PLANNING COMMISSION MEETING

February 25, 2026 – 6:00 PM

MEETING DATE: February 25, 2026
TO: Planning Commission
STAFF ORIGINATOR: Steven Gilmore, AICP, Assistant Community Development Director
AGENDA ITEM: PUBLIC HEARING - Hidden Creek South Preliminary Plat and Planned Unit Development
60-Day Deadline: April 21, 2026

Headwaters Land Group, represented by Mr. John Dobbs, has submitted applications for a Preliminary Plat and Planned Unit Development (PUD) Amendment for Hidden Creek South. The subject property consists of approximately 56.52 gross acres located south of Headwaters Parkway within the Headwaters Master Planned Unit Development (PUD) area.

PRELIMINARY SITE & UTILITY PLAN

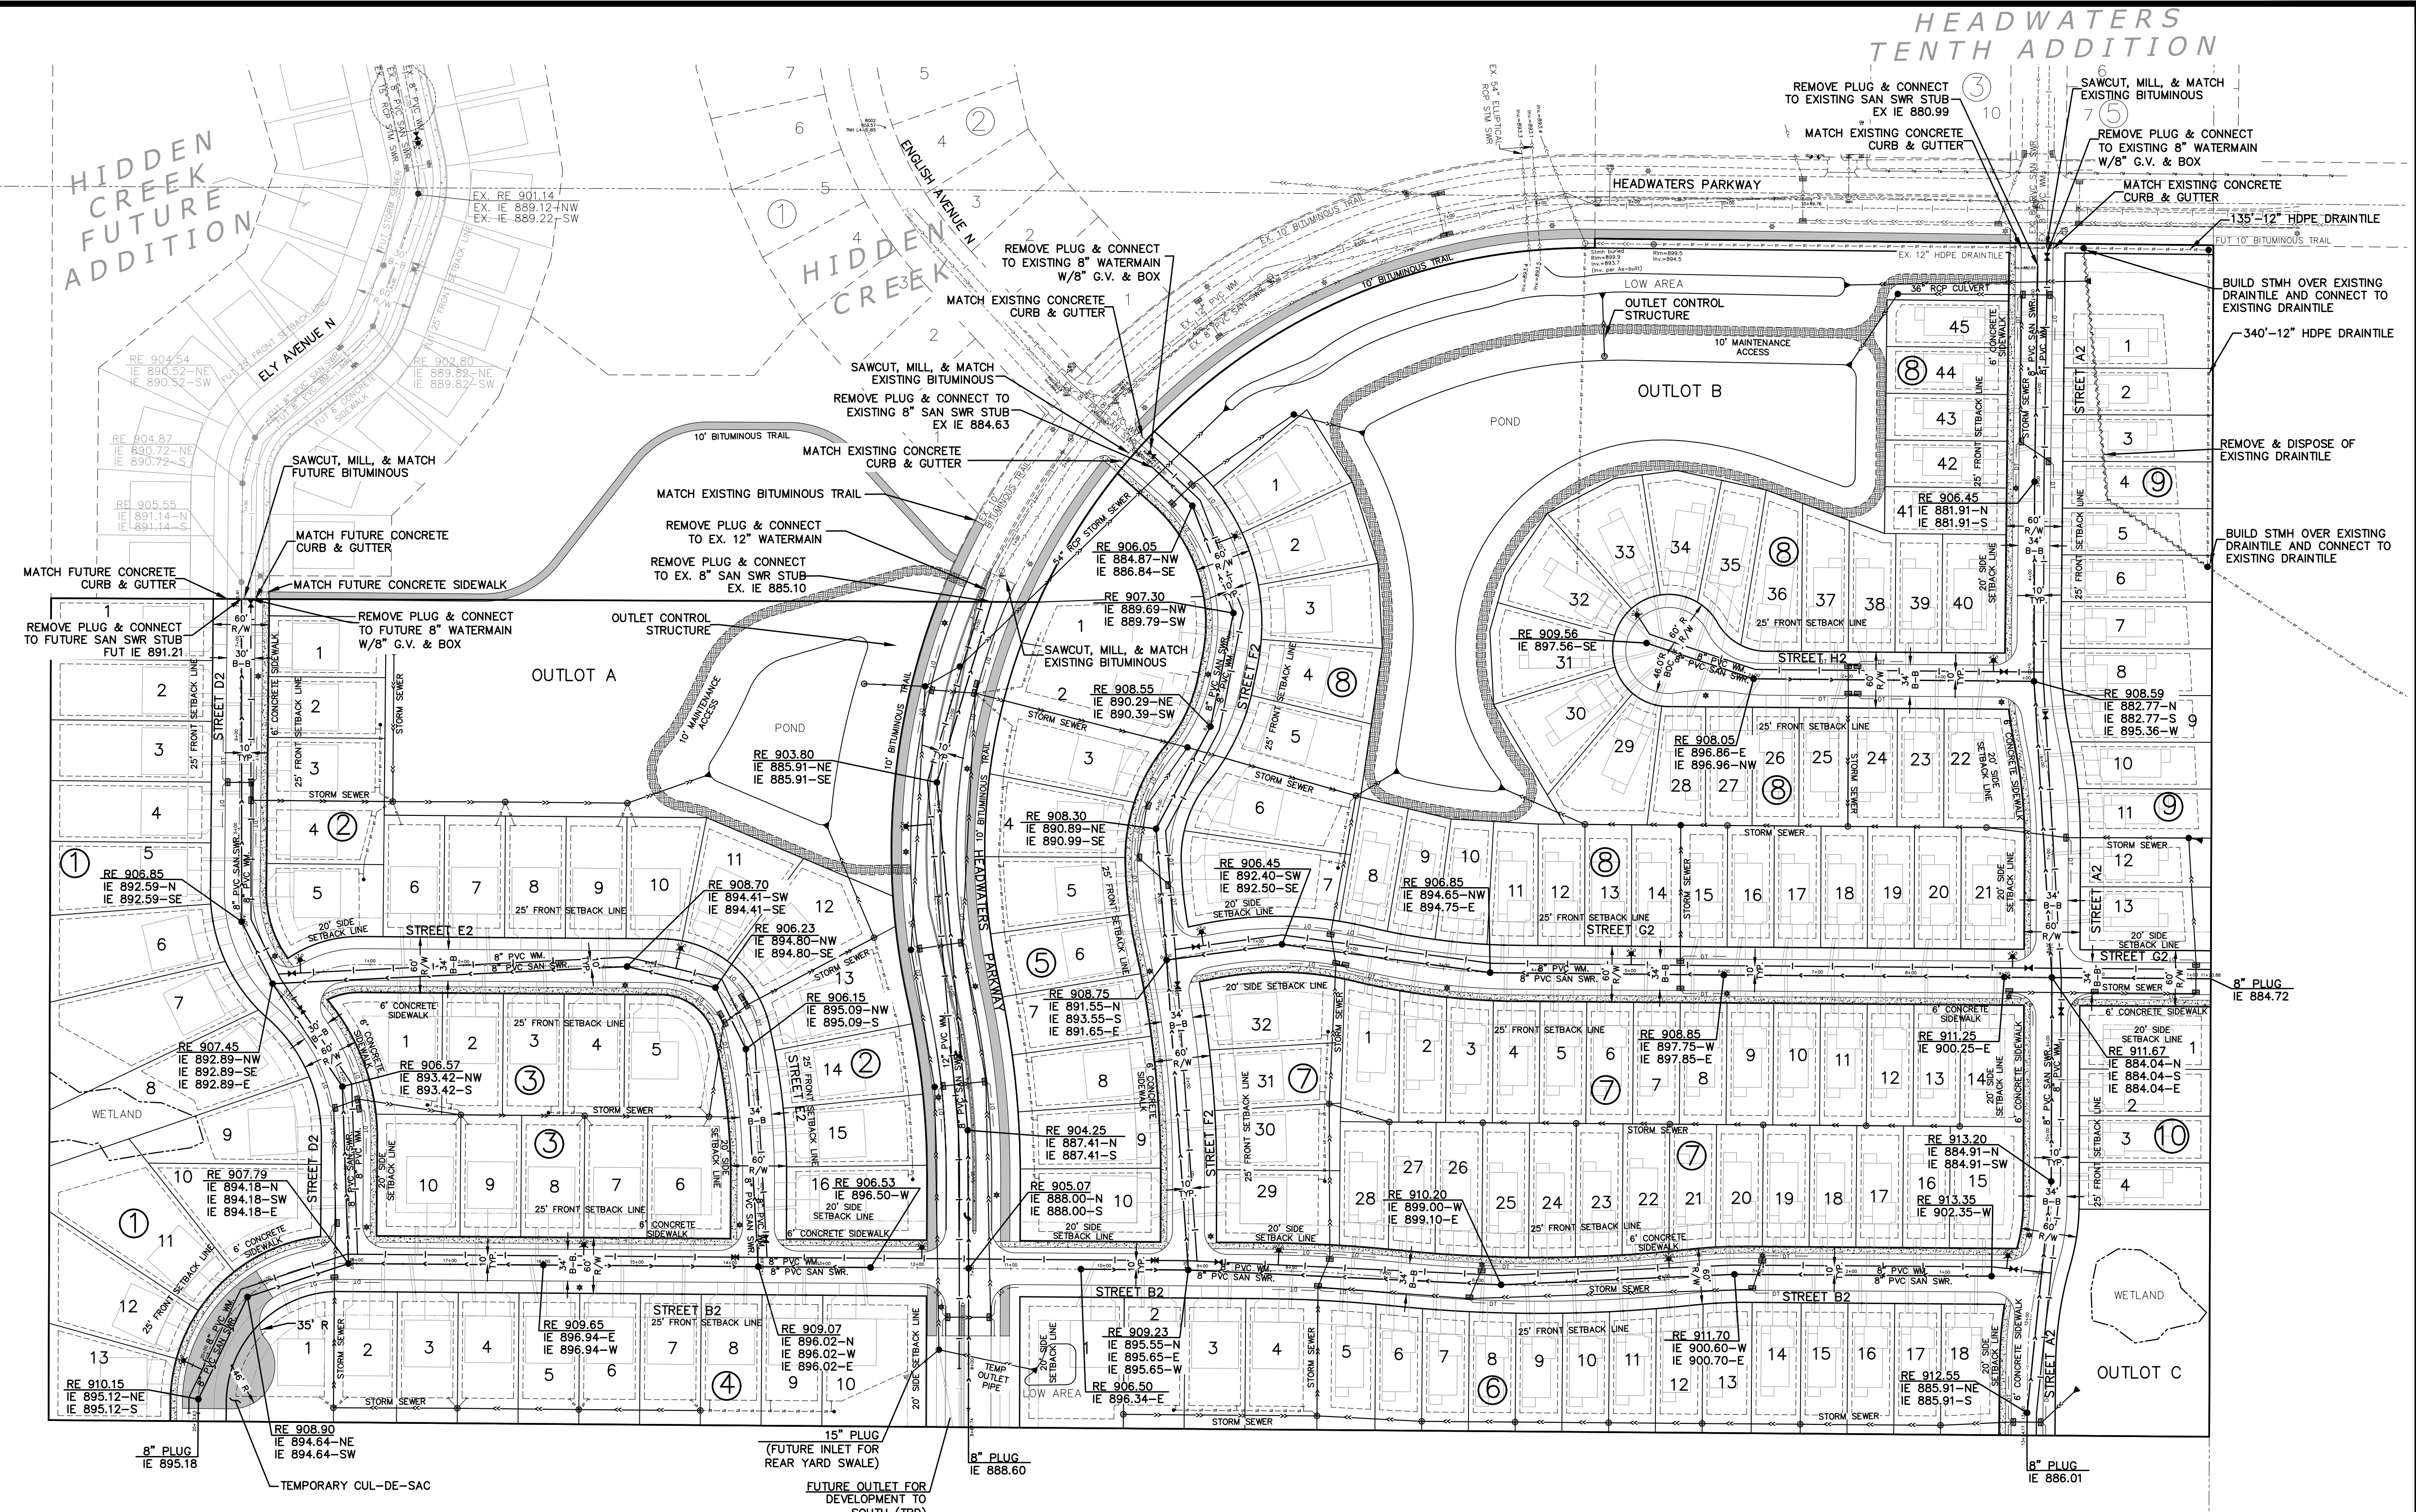
Sheets 7-8 Preliminary Site & Utility Plan

20. Sanitary sewer and watermain testing will be required per the current Forest Lake Public Works/Engineering Standards.
21. Sanitary sewer and watermain alignments may need to be adjusted if additional storm sewer runs are added to meet spread requirements.

22. Provide 50 scale plan/profile view sheets for proposed sanitary sewer and watermain, show storm crossings and sanitary service risers and heights in profile views.

23. Add labels for sanitary manhole/pipes (Rim, Inverts, Pipe Size/Slope/Material), hydrants, valves, fittings (tees, bends, plugs), and watermain pipe size/material.

24. Show proposed elevations for sanitary (invert) and water services (finished grade at curb box) and sanitary service wye stationing from downstream manhole for each lot.

25. Revise sanitary sewer and watermain layout as noted on the attached markup.
26. Obtain permanent easements on adjacent properties to extend sanitary sewer and watermain stubs as noted on the attached markup, to allow construction of the street to the plat line and prevent damage to the street when utilities are extended in the future.

27. Provide sanitary sewer and watermain services to Park area on Outlot A as noted on the attached markups.
28. The proposed 0.1-foot drop across manholes is not desired by the City for the sanitary sewer mains, revise as noted on the attached markups.

29. Revise sanitary manhole inverts as noted on the attached markup to eliminate conflicts (and provide min. 1.5' separation) between sanitary services and watermain at the upstream ends of the sanitary runs.

30. For outside drop manholes:
 - a. The first 20' (or 2 times the drop depth, whichever is larger) shall be ceramic lined DIP or PVC C900 DR 18 per City Detail SAN-3. Label drop depth on plan/profile.

- b. The interior of drop manholes shall be lined with Zebron, Spectrashield, or approved equal per City Detail SAN-3.
31. Coordinate any water shut downs with City staff a minimum of 72 hours prior to service interruption to allow for proper notification to the affected properties.

32. All watermain shall have 8.0' minimum cover.
33. Design watermain depth at hydrant locations to ensure hydrant extensions are not used.
34. Revise gate valve layout and hydrant spacing (250' radius to cover building pads) as noted on the attached markups.

35. Water services and curb stops shall not be installed in driveways or have planned landscaping near them.
36. Hydrants adjacent to sidewalks shall be centered 4' from back of curb to provide a minimum 1' clear zone from sidewalks, all other hydrants shall be centered 5' from back of curb.

37. Watermain stubs shall have plugs tapped with 1" corp, 1" curb stop, and 1" service pipe for watermain blowoff for flushing and testing.
38. Provide 50 scale plan/profile view sheets for proposed streets, including signing and striping.

39. Provide intersection and pedestrian ramp detail sheets.
40. Design parameters for street alignments and profiles are included in the attached markup.

43. Permanent barricades with "Future Road Extension" signs are required at all stub street locations per City Details STR-11/STR-12.
44. Provide temporary barricades at Ely Ave N (Northwest side of development) until base course of pavement is completed.

45. Revise Street H2 cul-de-sac to meet City standard of 51' radius to back of curb.
46. Revise sidewalk and street light locations as noted on the attached markup.

1 OVERALL LANDSCAPE PLAN
L1

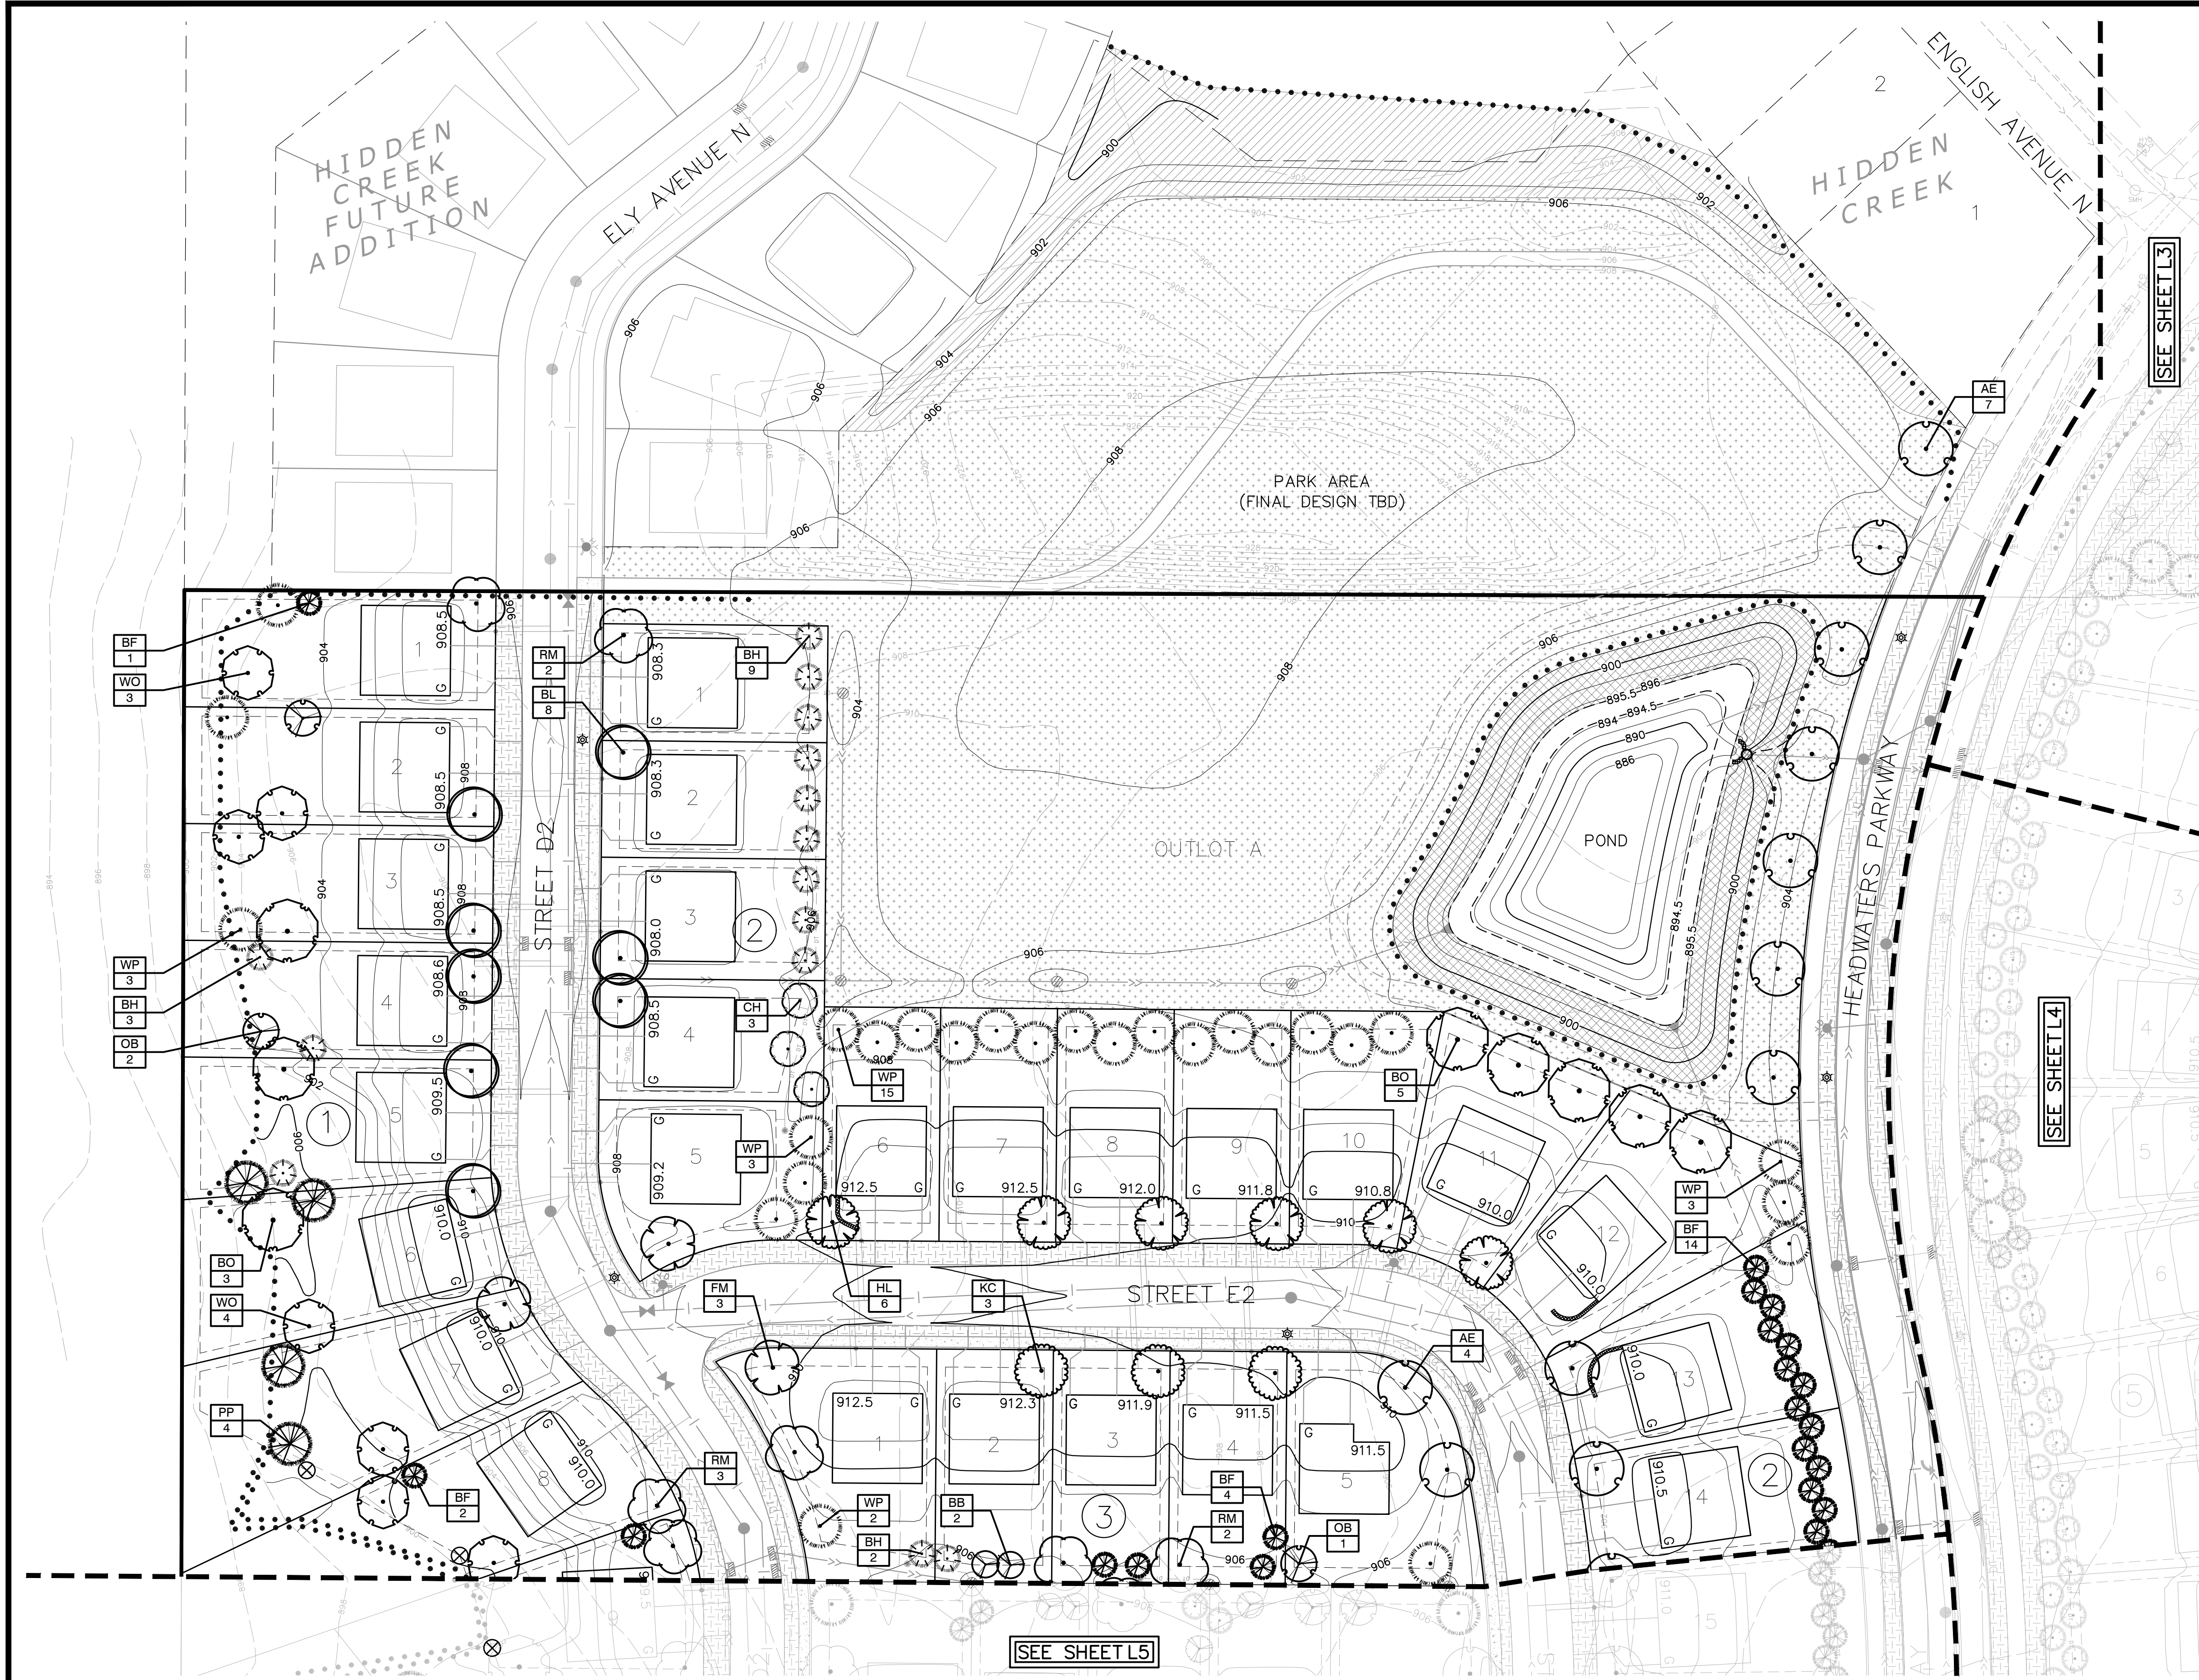
A plan has been provided which depicts 4 trees per lot. This plan will require revisions to remove the landscaping proposed in the City's right-of-way and drainage and utility easements as identified in the City Engineer's February 4, 2026 letter.

Sheets L1-L5 Preliminary Landscape Plans

8. Documentation of approved wetland delineation and required buffers from RCWD, reflected on the Final Plat.
9. Revised landscaping plans removing landscaping from City right-of-way and drainage and utility easements.
